Item # 1

Modifications to DTC Standards Heaven's Door Distillery 19 – O'Connell Tuck Hinton Architects, applicant; A.G. Hol

APPLICANT REQUEST

A request to approve modifications to the Major and Collector Street Plan and various standards of the DTC for property located at 610, 612, 614 5th Avenue South (0.76 acres), within the Lafayette subdistrict of the DTC.

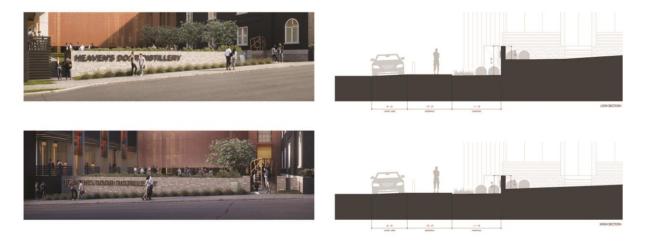
The building addition is not built to the required build-to line along 5th Avenue South. This is, in part, to complement the placement of the existing historic structure by receding the massing of the building addition.

The courtyard area includes various elements that establish an edge condition, which meets the intent of the build-to standard to maintain a consistent street wall effect. A site wall setback approximately 11 feet from the property line, in addition to plantings, sculpture, and signage, contribute to creating an edge condition. The courtyard helps to separate the built addition from the existing historic structure.
